CALCULATED: BRO: CHECKED: PSB: TYPICAL SECTIONS MED - 3 - 09 . 04 5/80

CALCULATED MJB CHECKED PSB	PAVEMENT SUBSUMMARY	MED - 3 - 09 . 04
-------------------------------------	---------------------	-------------------

ROUNDABOUT INTERSECTION DETAIL

ROUNDABOUT
SPLITTER ISLAND DETAIL

ROUNDABOUT
 INTERSECTION DETAIL

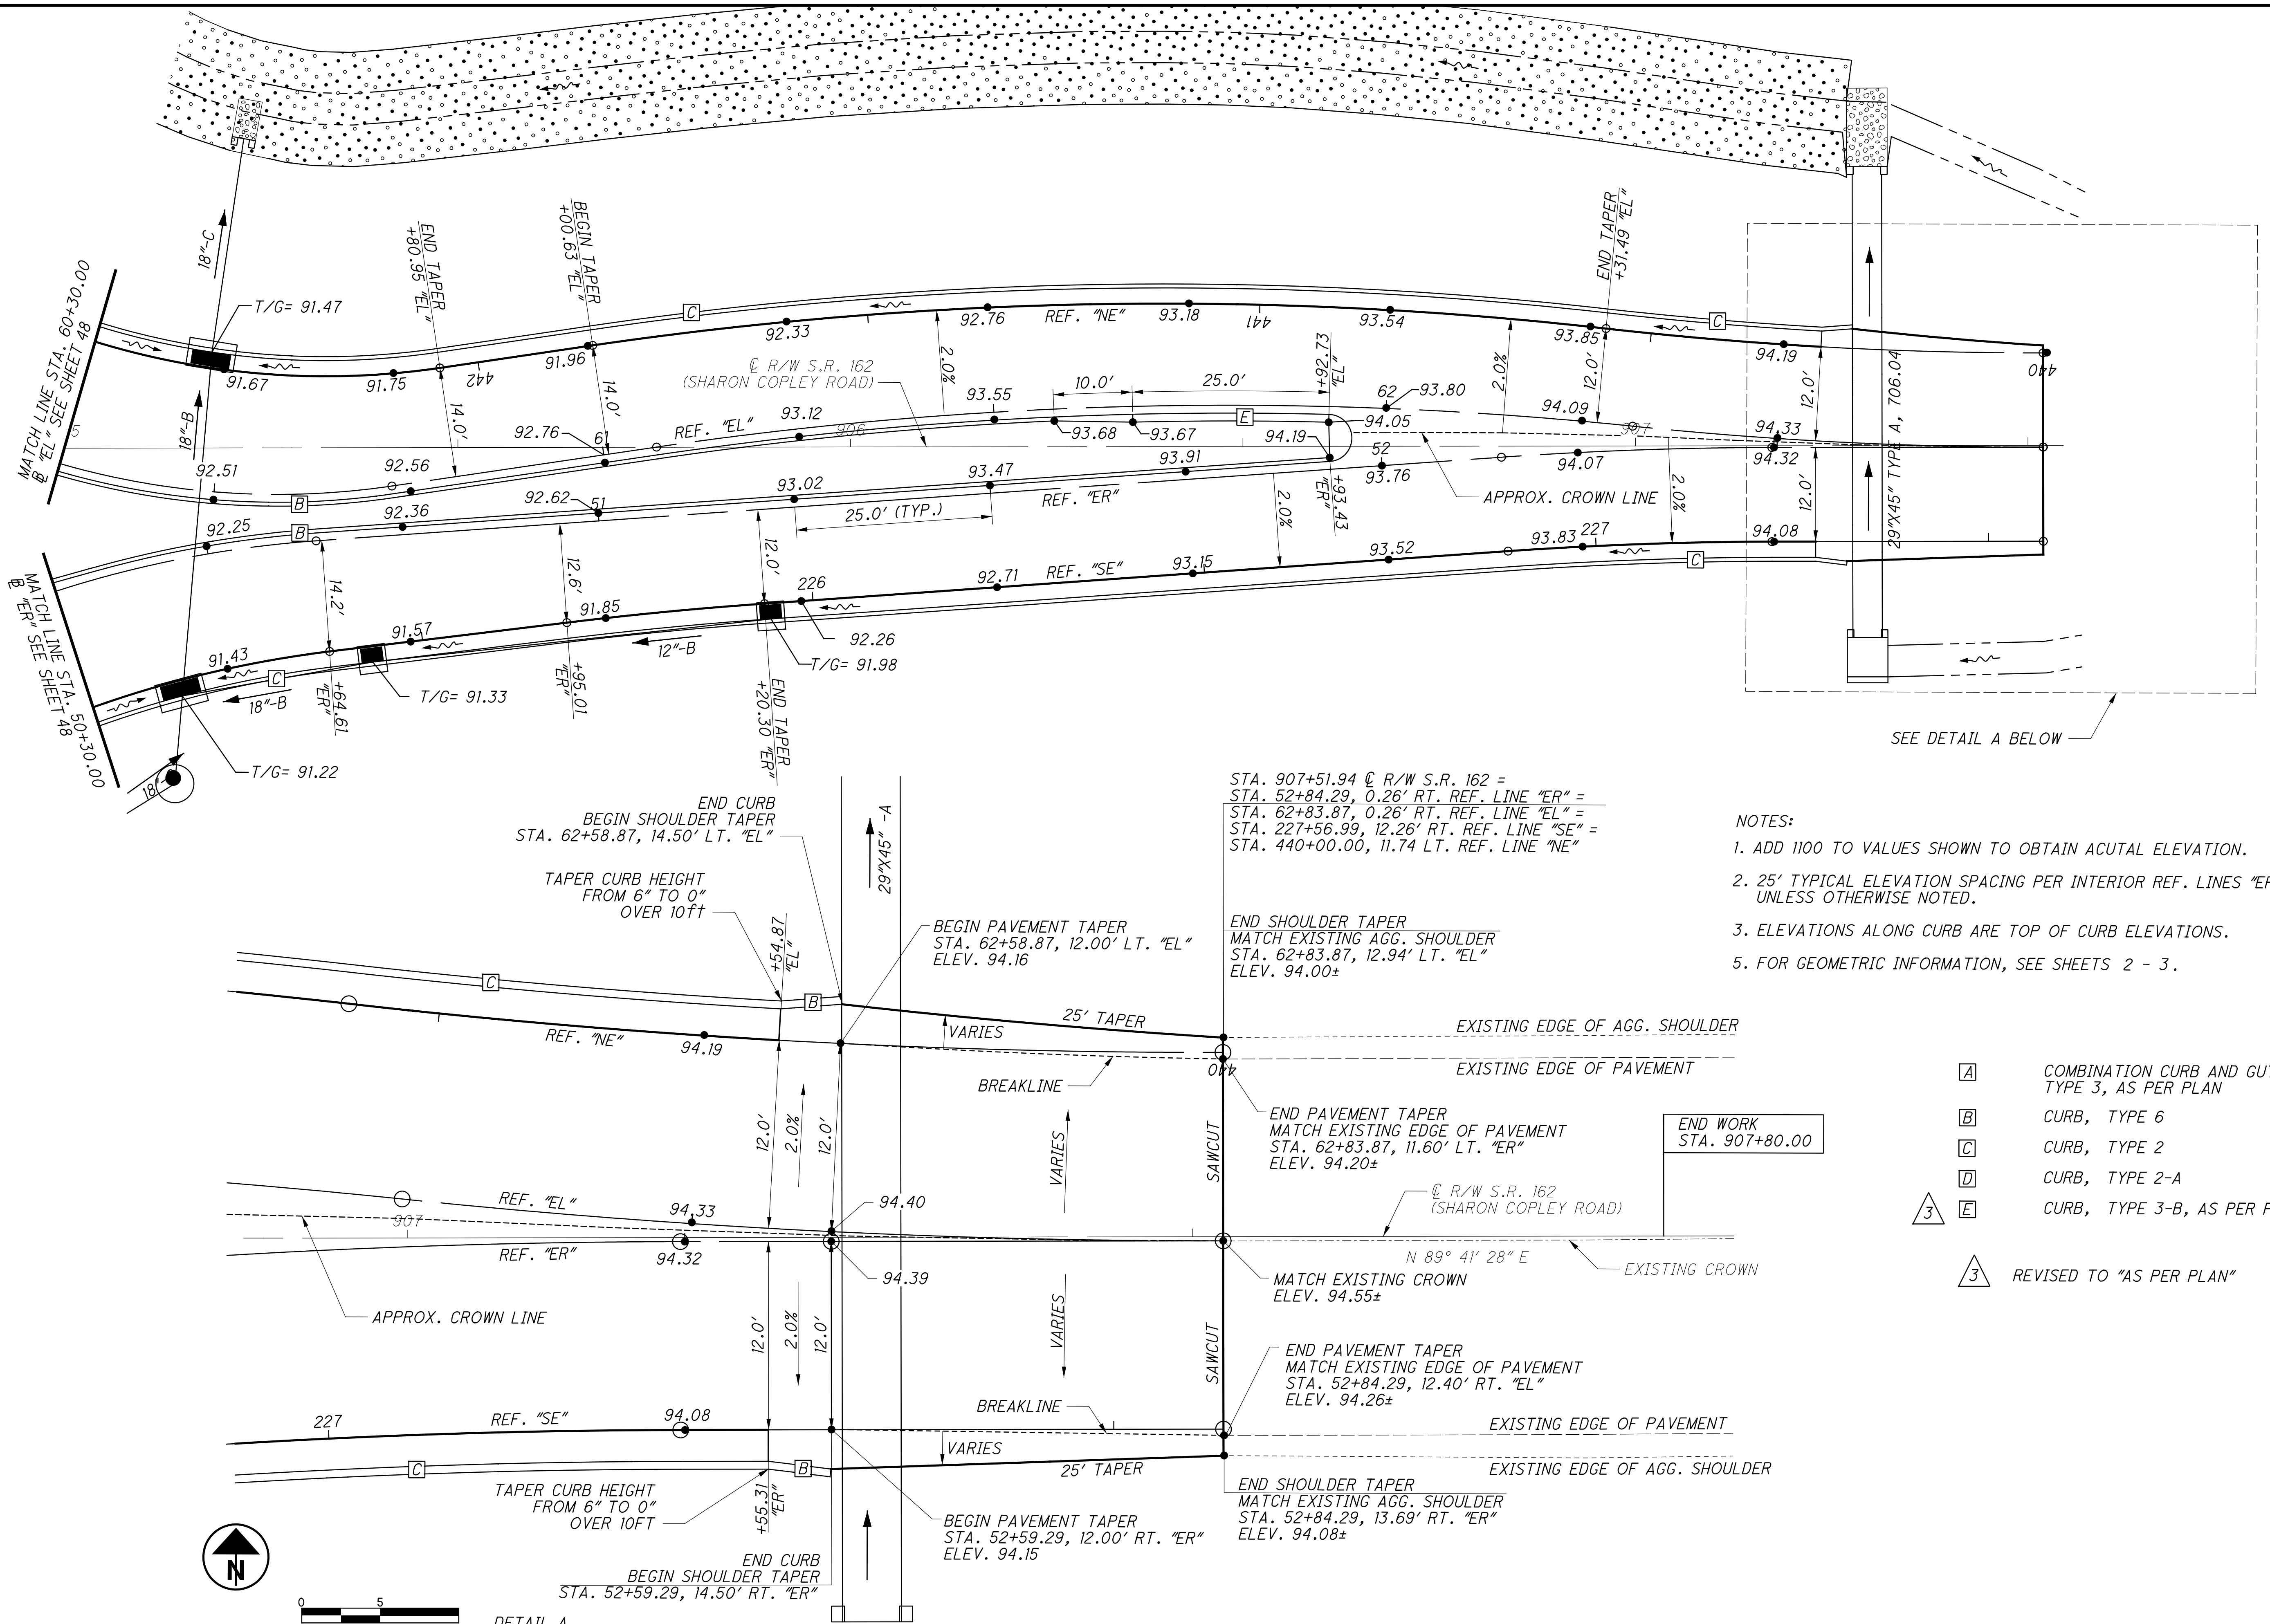
3 REVISED TO "AS PER PLAN"
